FED. ROAD DIST. NO.	STATE	PROJ. NO.	FISCAL YEAR	SHEET NO.	TOTAL SHEETS
HAWAII	HAW.	I-H3-1(72)	1991	C.O. ADD. 7	521

TYPICAL ROADWAY SECTIONS
H3 KANEHOE INTERCHANGE

INTERSTATE ROUTE H-3
F.A.I. PROJ. NO. I-H3-1(72)

**TYPICAL RAMP
SECTIONS AND DETAILS**

FED. ROAD DIST. NO.	STATE	PROJ. NO.	FISCAL YEAR	SHEET NO.	TOTAL SHEETS
HAWAII	HAW.	I-H3-1(72)	1991	C.O. ADD. 9	521

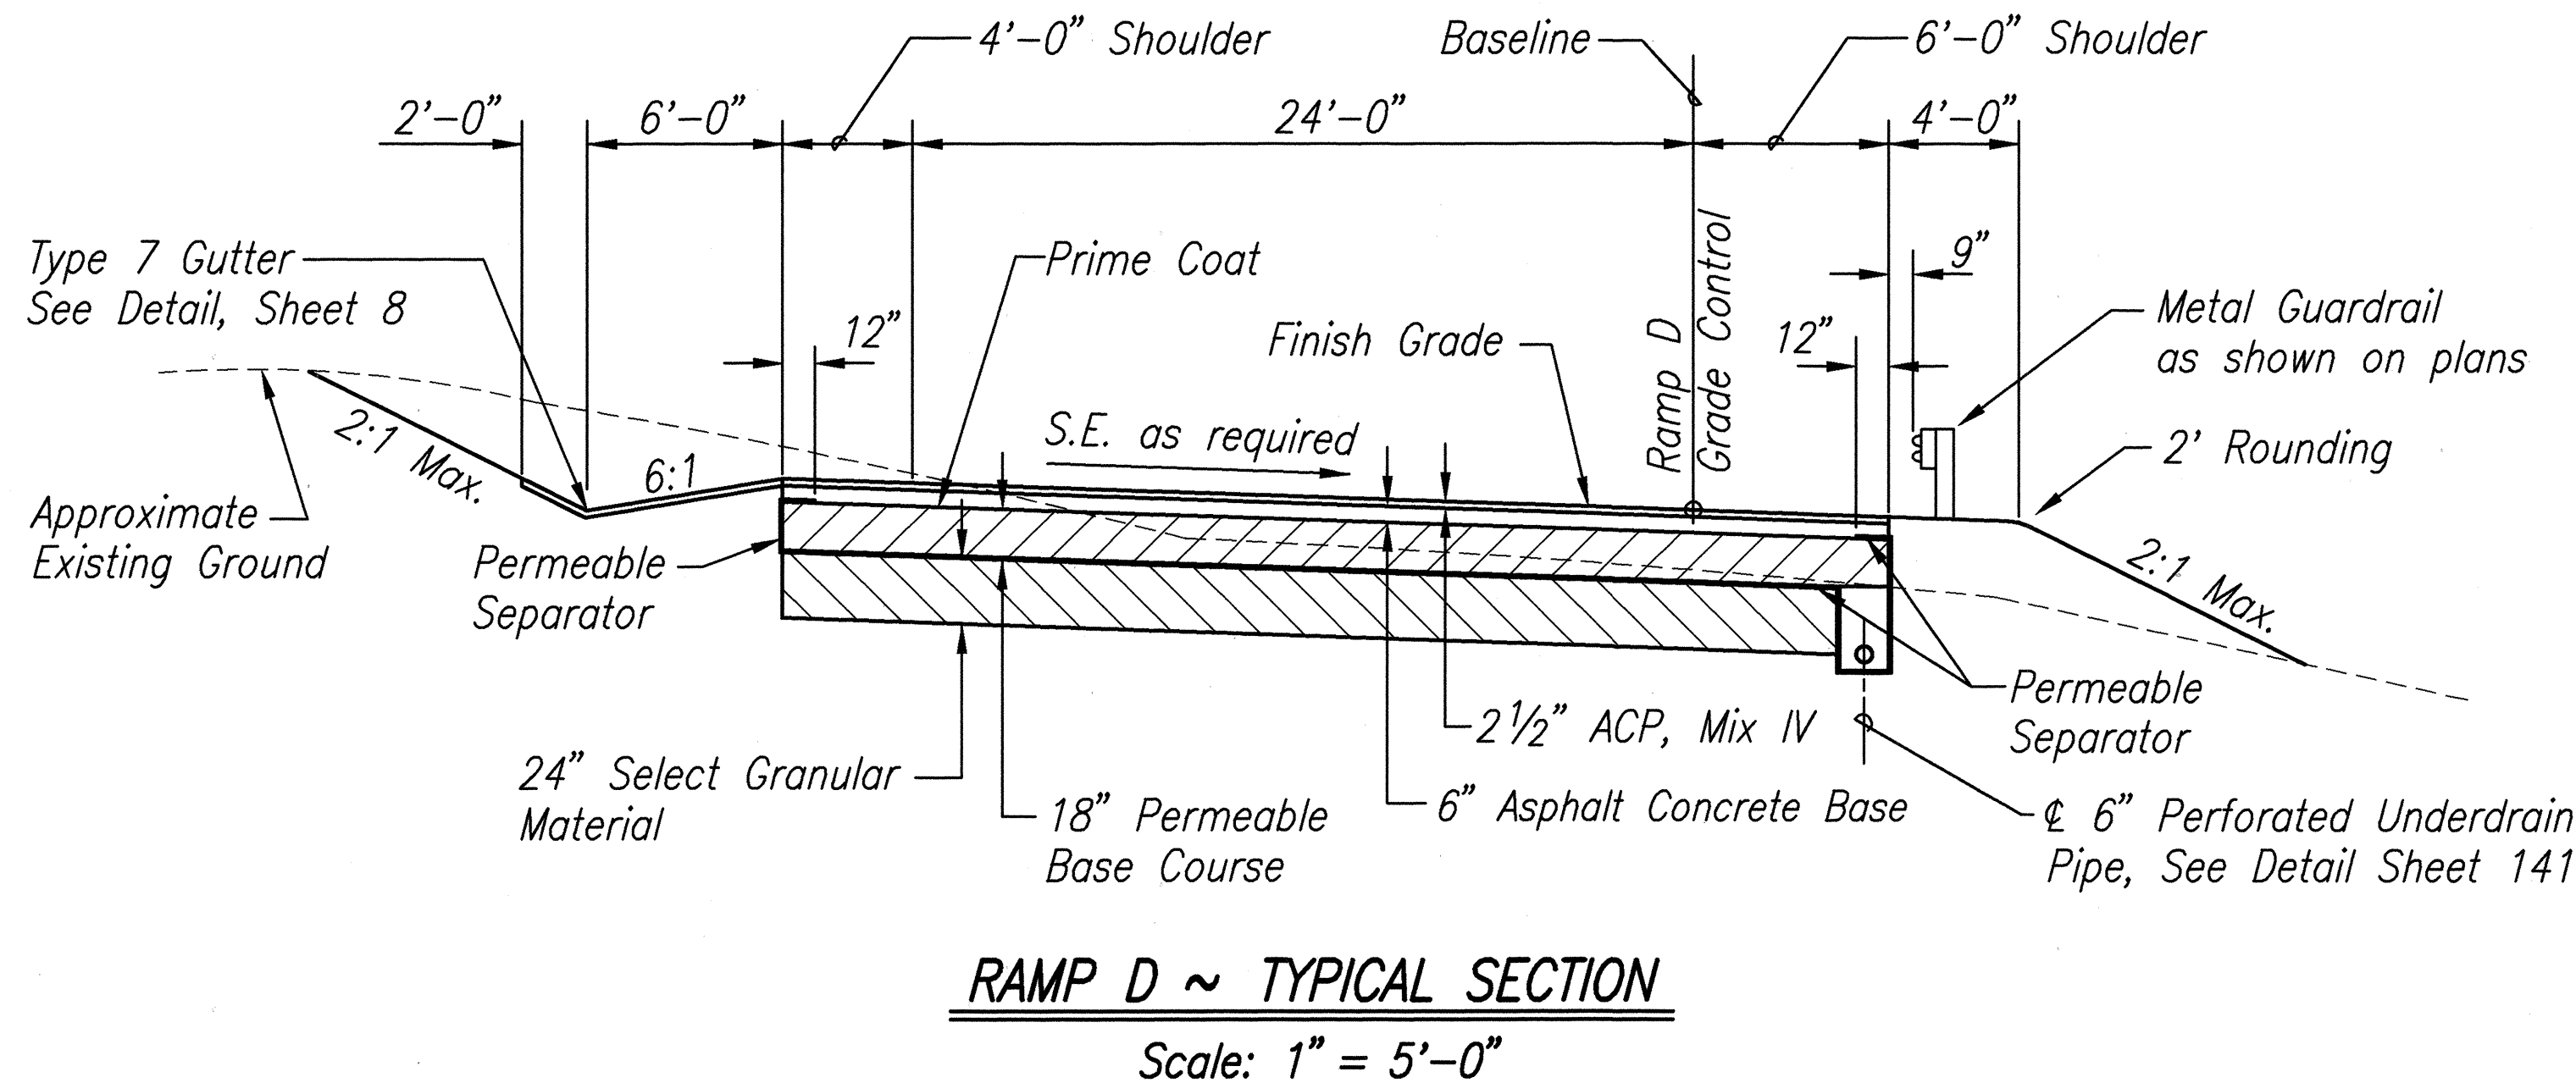
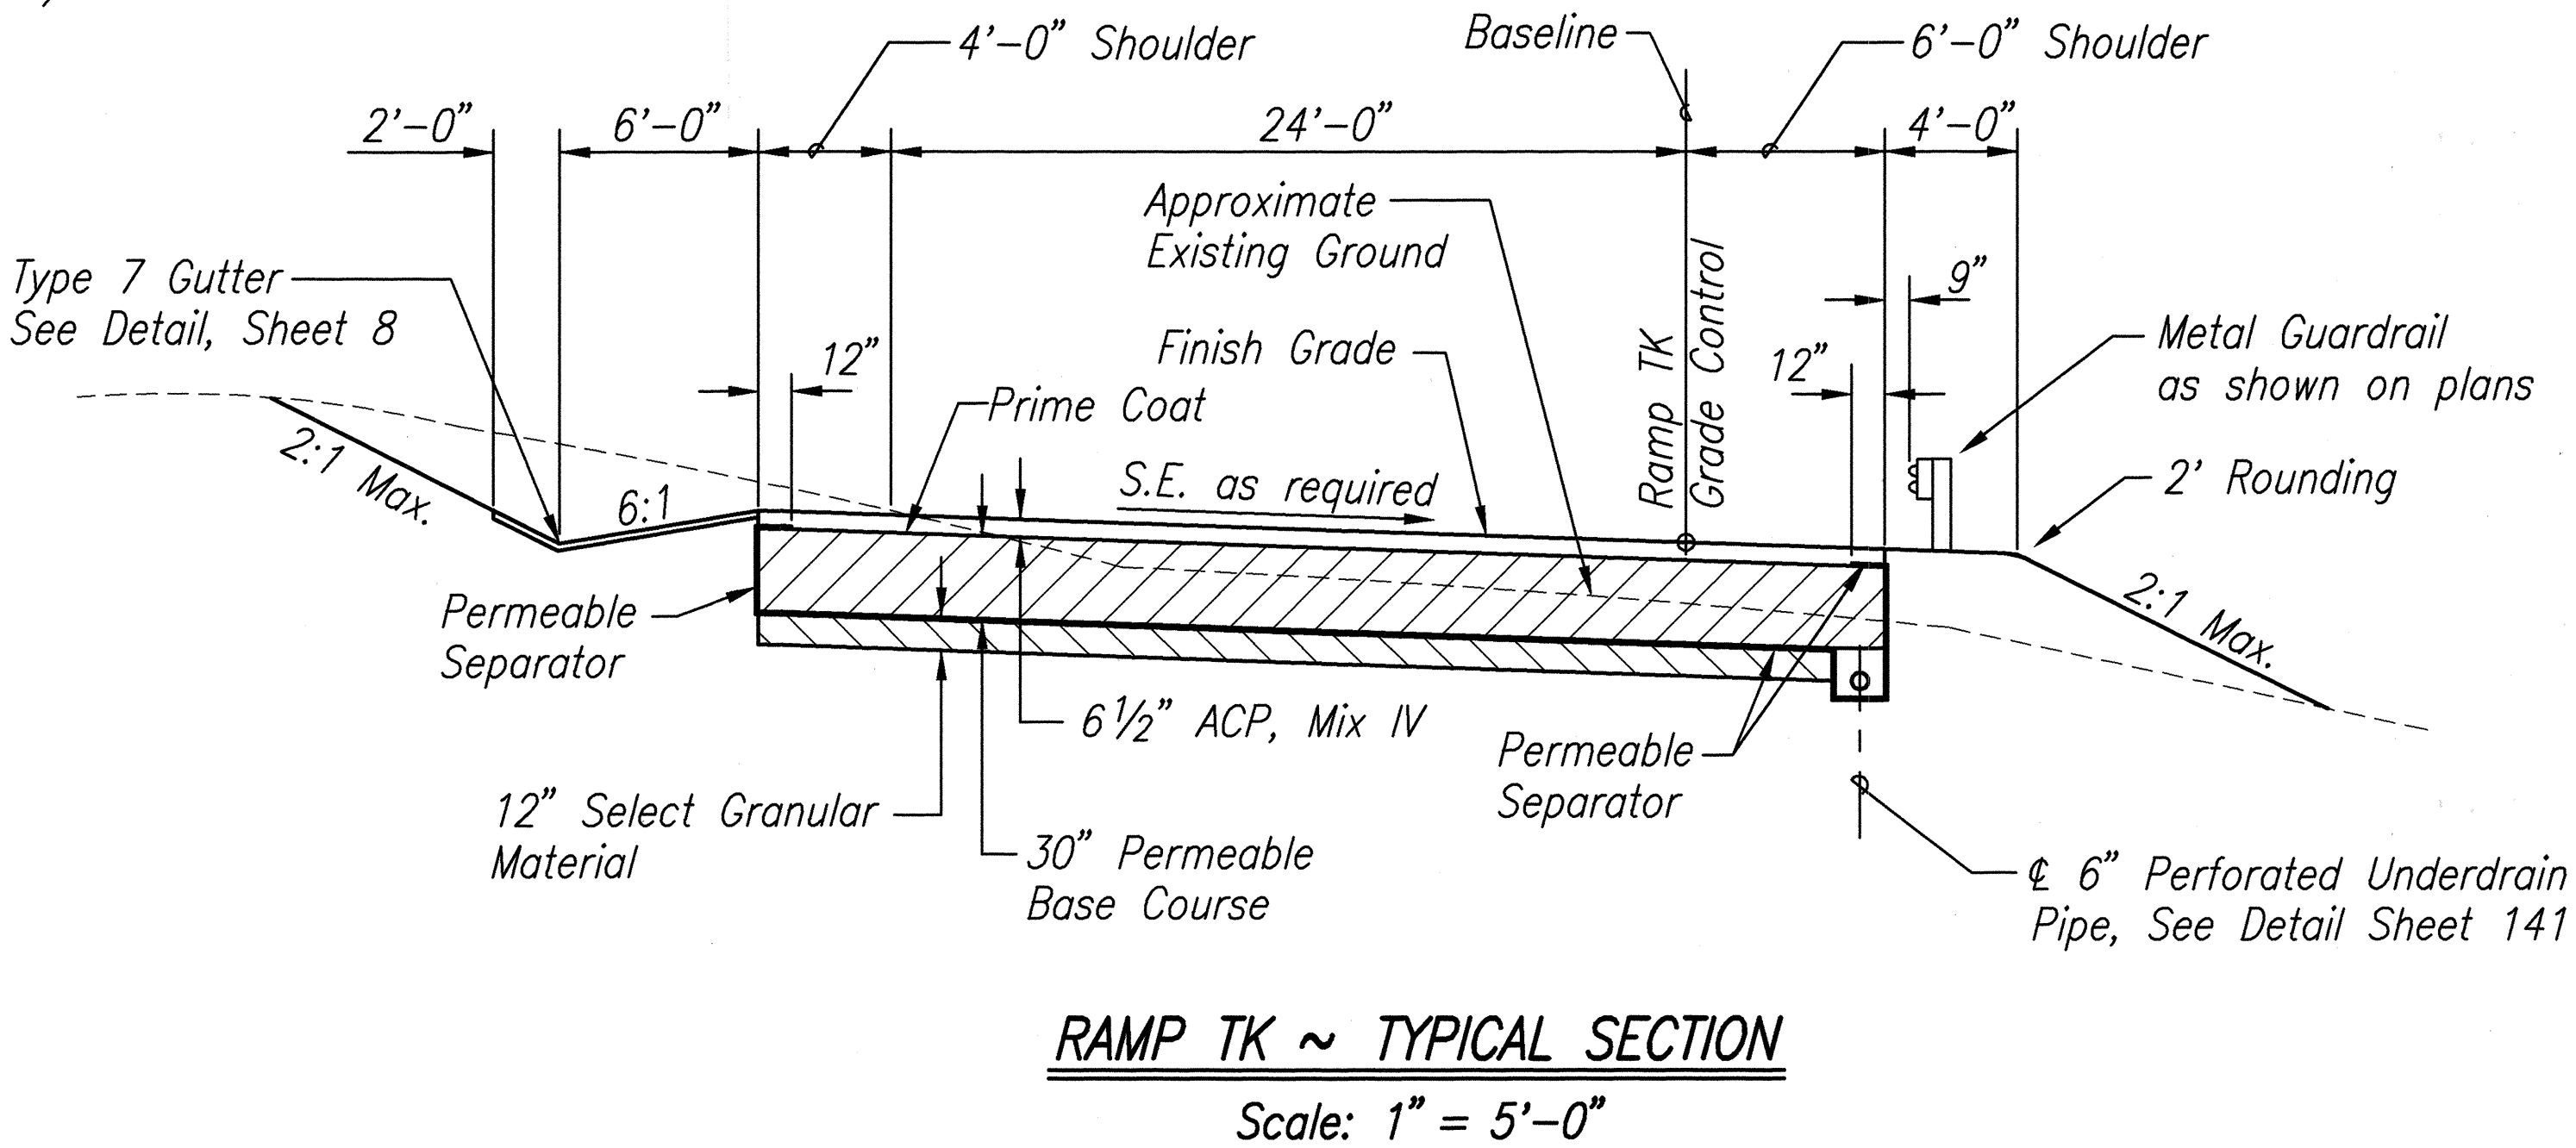
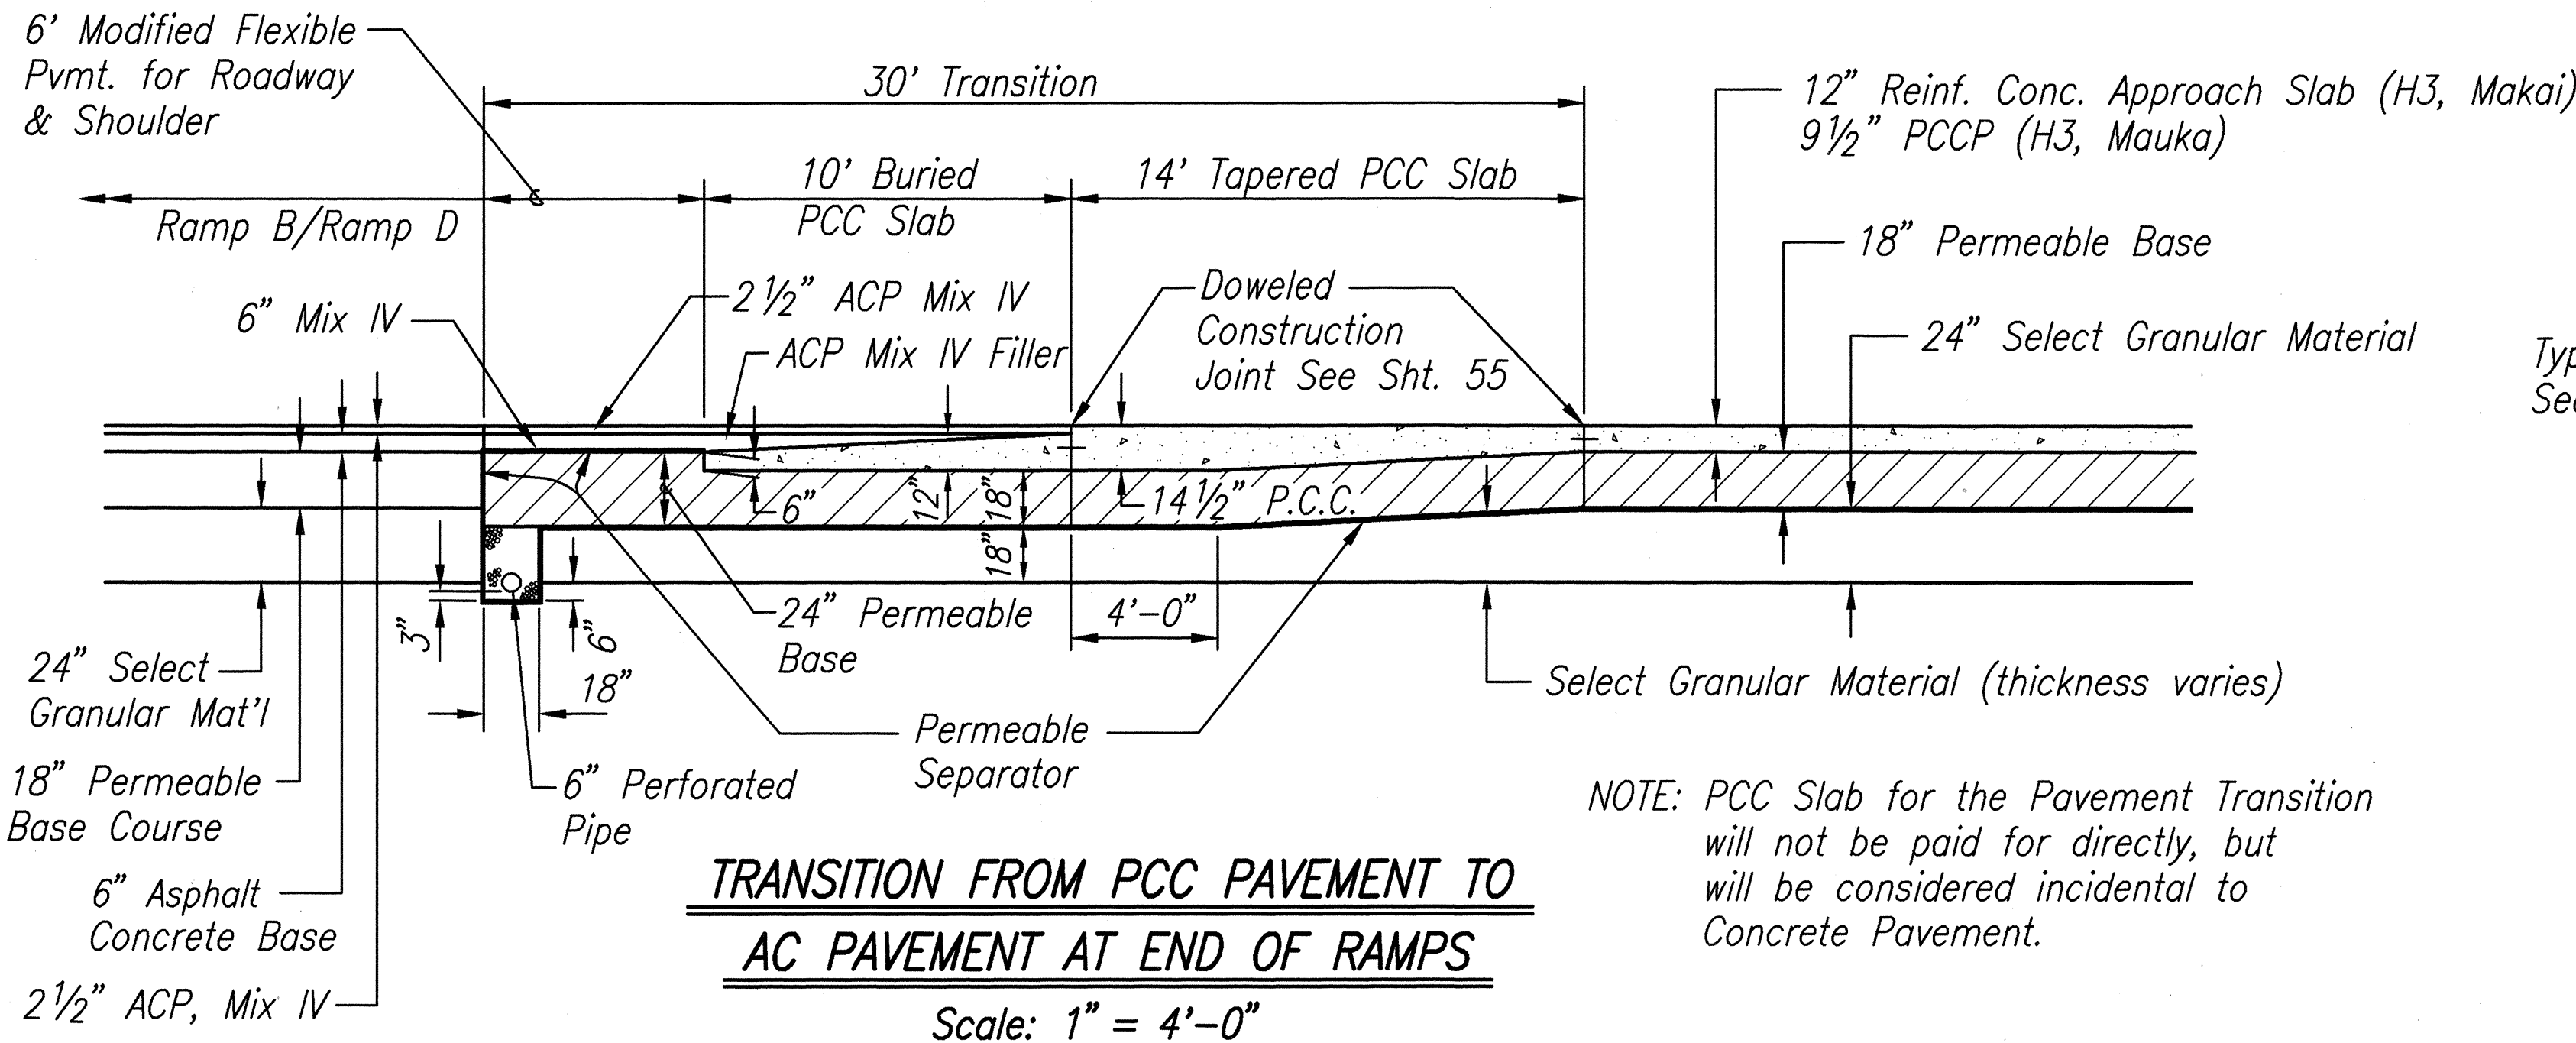
9/11/92	Revised Pavement Transition Detail.
3/27/92	Added Note to Transition Detail.
2/21/92	Added Ramp B & D pavement structure to Transition from PCC to AC pavement. Added 4" Permeable Base Course under the Type 2F-A Gutter. Void between post & gutter of Type 2F-A gutter shall be filled w/ hot mix, no. V.
1/27/92	Revised Type 2 Gutter to Type 7 Gutter. Added Metal Guardrail callout to Type 2F-A Gutter Detail.
DATE	REVISION
